## Addendum

No. TEN Date: 9/11/08

Project: ADDITIONS AND RENOVATIONS TO  
DALRAIDA ELEMENTARY SCHOOL  
FOR  
THE MONTGOMERY COUNTY BOARD OF EDUCATION  
MONTGOMERY, ALABAMA

Project No. 07-138

JOB NO. 08084 SHEET NO. SK3

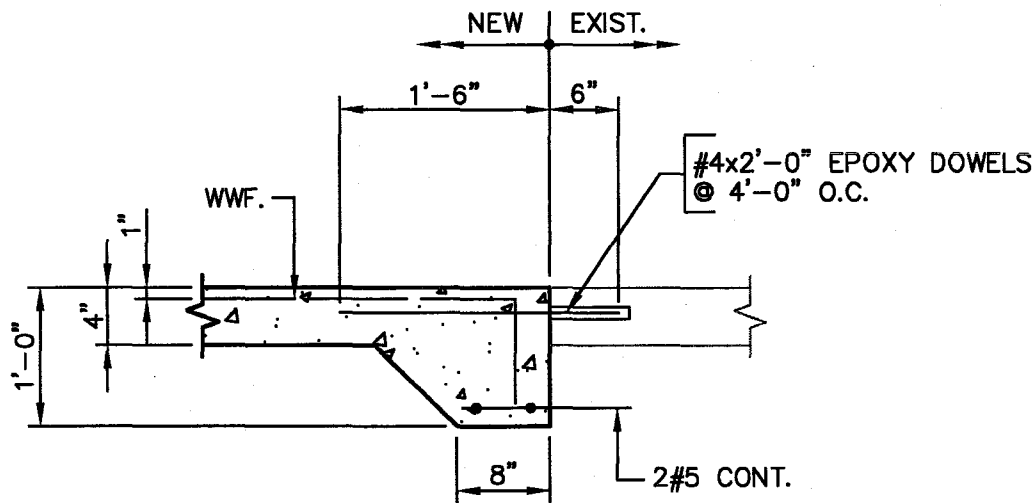
- Item 1. General Notes- Item #9  
Contractor not required to design openings
- Item 2. Pre-fabricated Lt. Gage Metal Trusses  
Connections shall be designed by light gage truss designer

## TYPICAL NEW SLAB ON GRADE TO EXIST. SLAB CONNECTION DETAIL

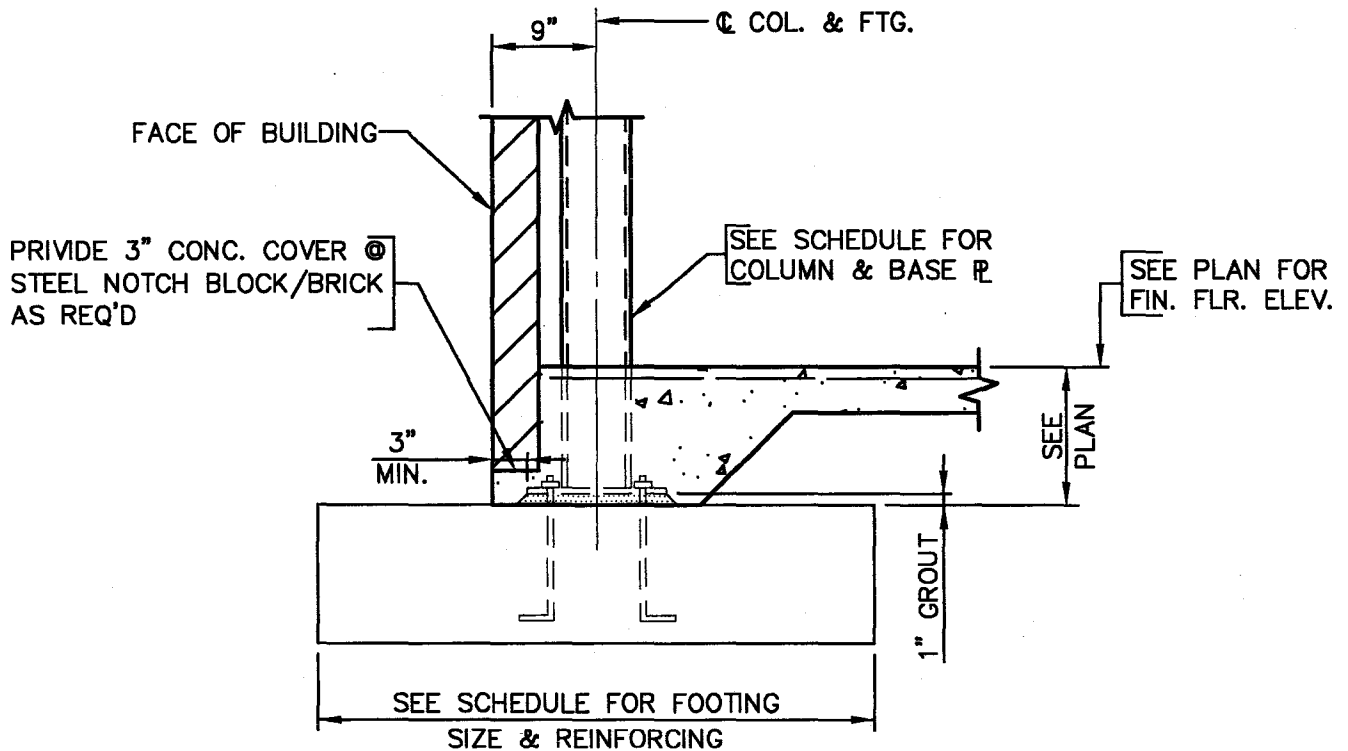
- Item 3. Typical New Slab on Grade to Existing Slab Connection Detail  
Detail only applicable to areas in which conditions call for a new slab on grade and an new-to-existing slab connection as graphically illustrated on arch. plans

PROVIDE NEW 4" CONC. SLAB REINF. W/ 6x6xW1.4xW1.4  
W.W.F. WHERE REQ'D TO MATCH FINISH FLOOR.

TYPICAL DETAIL @ EXIST.  
STAIR INFILL

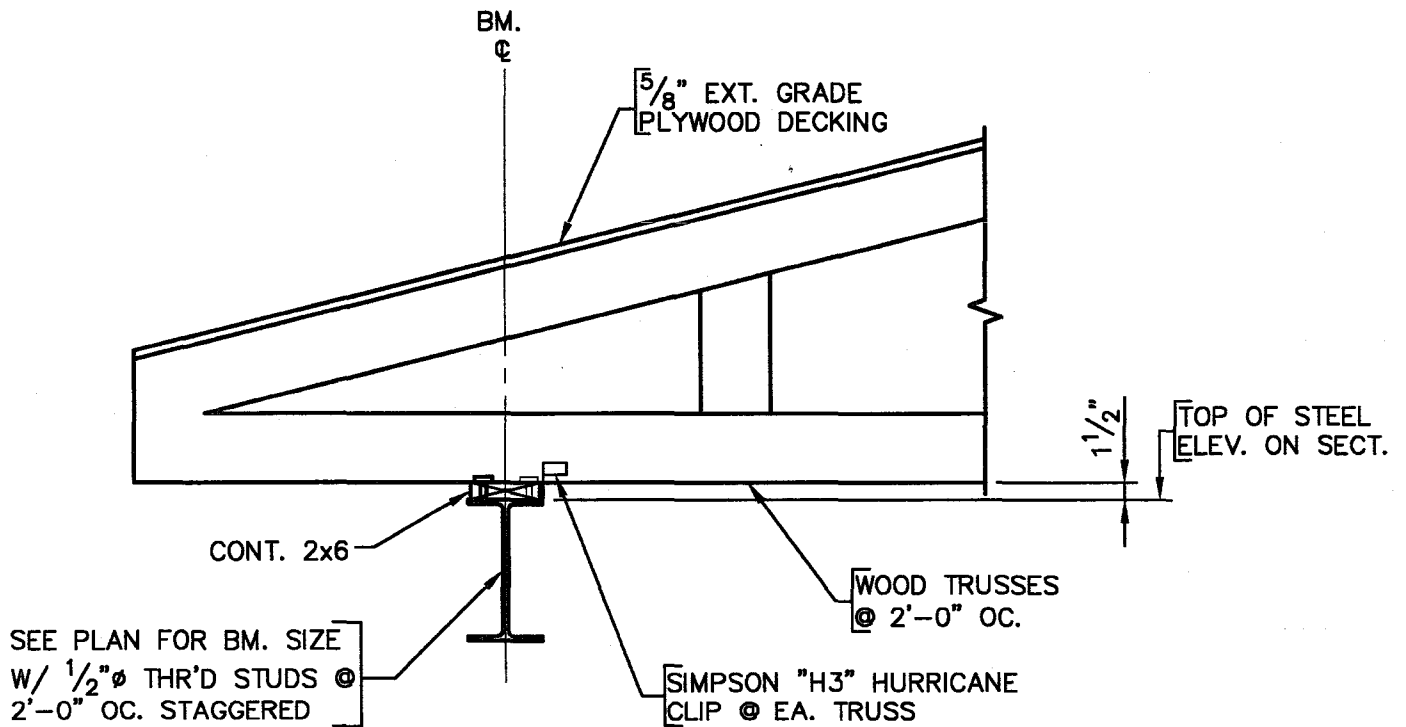
- Item 5. Typical Detail @ Existing Stair Infill  
Detail applicable to area where existing stair is to be fill in with floating slab. Infill includes three inch (3") deep, 16 gage galvanized composite floor deck supported with L6x6x $\frac{3}{8}$  steel angle with  $\frac{3}{4}$ " expansion bolts at two feet (2'-0") O.C. Add additional reinforcing steel, two (2) MC10x25 with  $\frac{3}{4}$ " expansion bolts spaced at a two feet (2'-0") O.C. maximum, to existing concrete beam as shown

**SECTION**  
3 3A  
S5.3 S5.3  
 $\frac{3}{4}'' = 1'-0''$

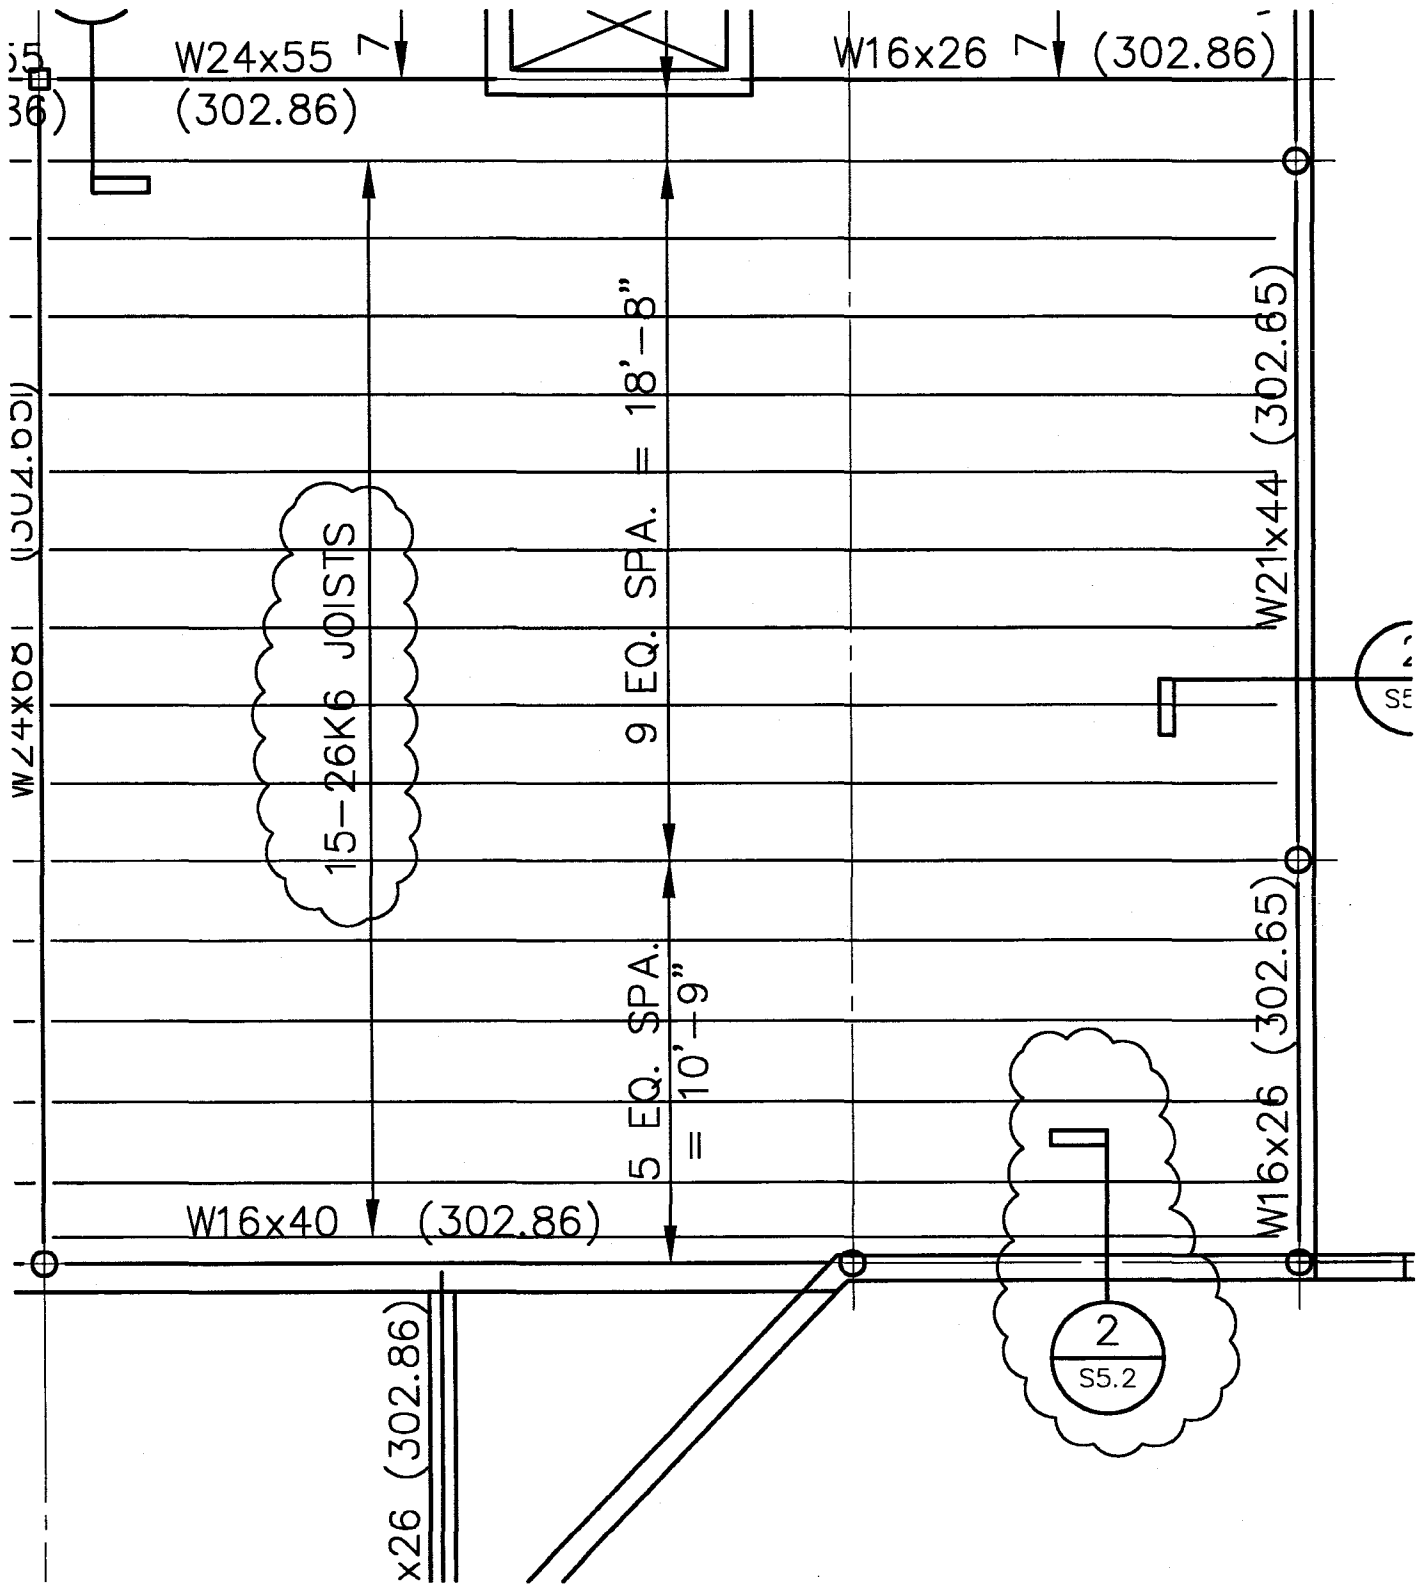
- Item 7. Section Note  
All exterior brick bears at a minimum of eight inches (8") below grade  
(Example attached)
- Item 8. Section 2/S5.2  
One (1) 26K6 joist added at FEMA wall to adhere to FEMA guidelines
